## ADDENDUM #1:

# Butler County Jail Remodel

<b>ADDENDUM #3:</b>
---------------------

## ADDENDUM #4:

## Detail 3, Sheet 1. A501

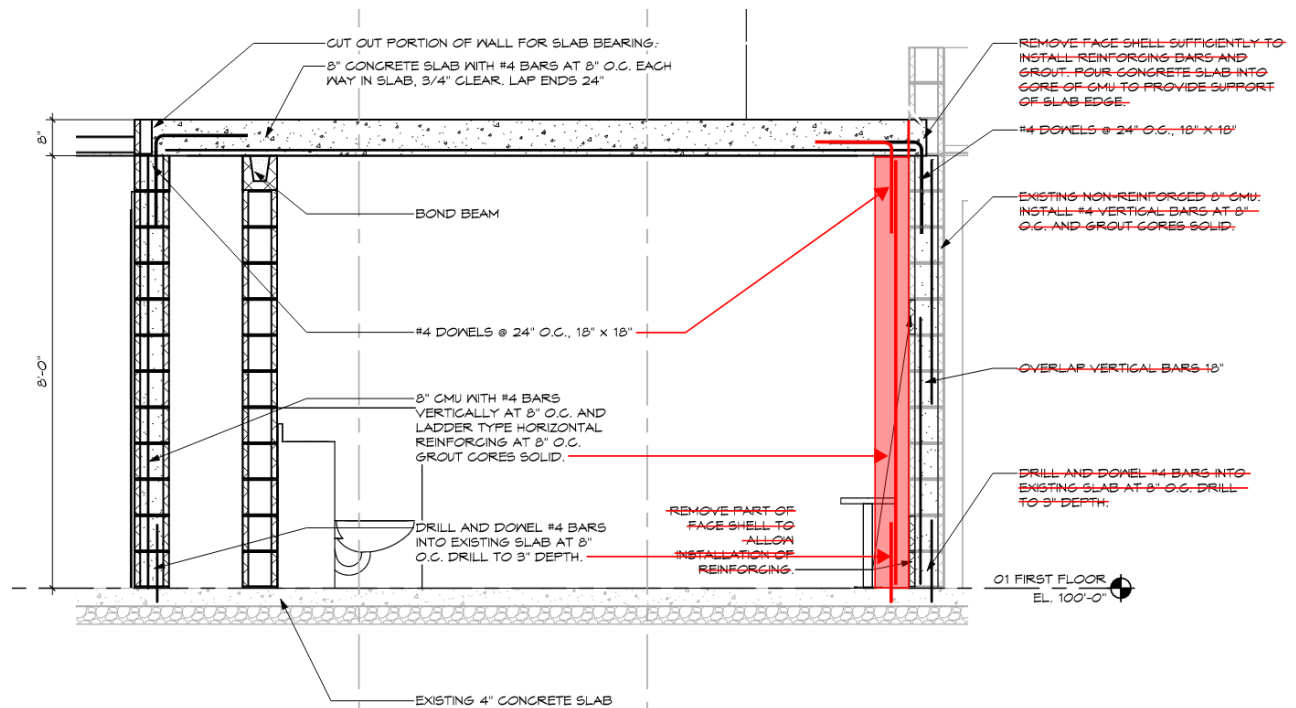
1. Sheets 1.A101 and 1.A501: At the contractor's option, in lieu of reinforcing and grouting the existing wall on the south side of Isolation MS 16, MS 17, and MS 18, a new 8" reinforced and grouted concrete masonry wall may be constructed in front of the existing wall. The reinforcing shall be the same as that shown for the north wall of these isolation rooms and be pinned to the slab. The entirety of the isolation rooms shall be shifted 8" North to accommodate the additional wall thickness. A revised drawing will be issued to the successful contractor based on the sketches below.

## Pneumatic Manifold and Wiring Panel Location

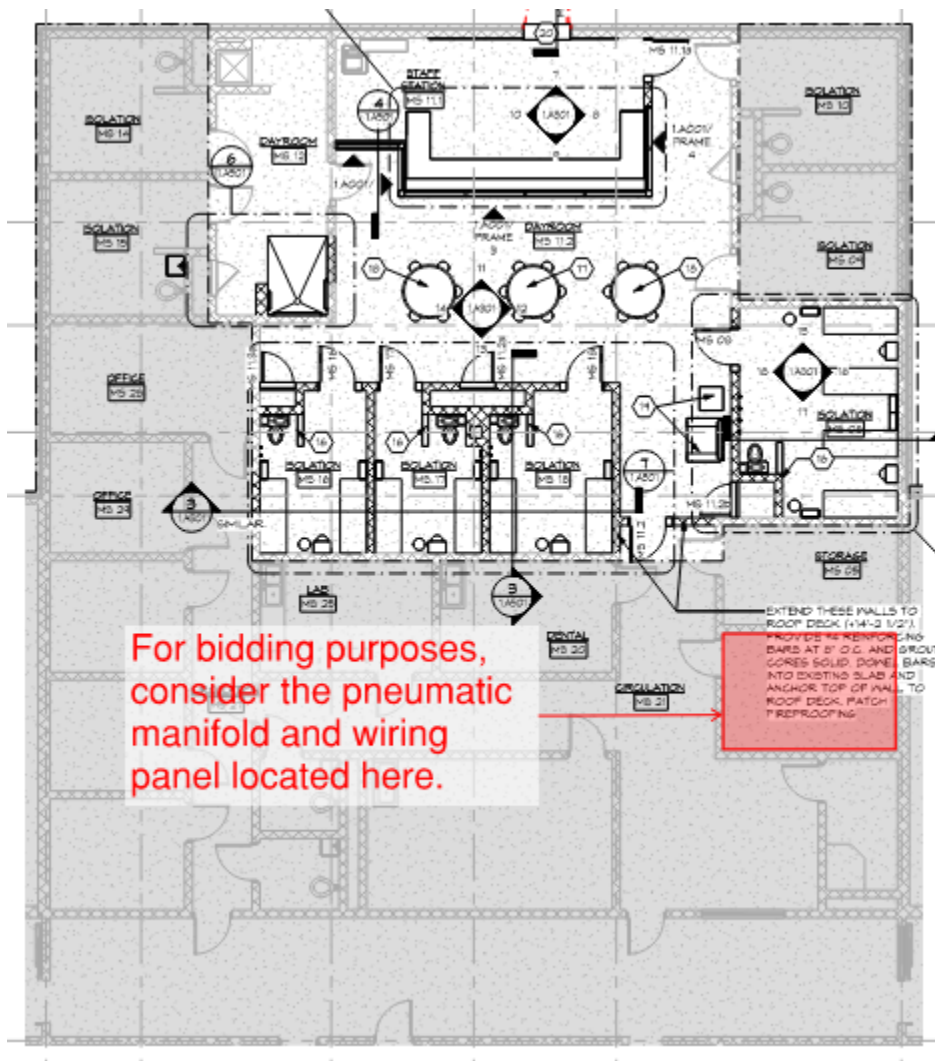
2. **Question:** The documents do not show where the existing manifold is located in the building. This will need to be known for the distance run. **Answer:** See plan below for location for bidding purposes. Exact location will be confirmed with successful contractor.

4. **Question:** Where is the location of the control wiring panel. **Answer:** See plan below for location for bidding purposes. Exact location will be confirmed with successful contractor.
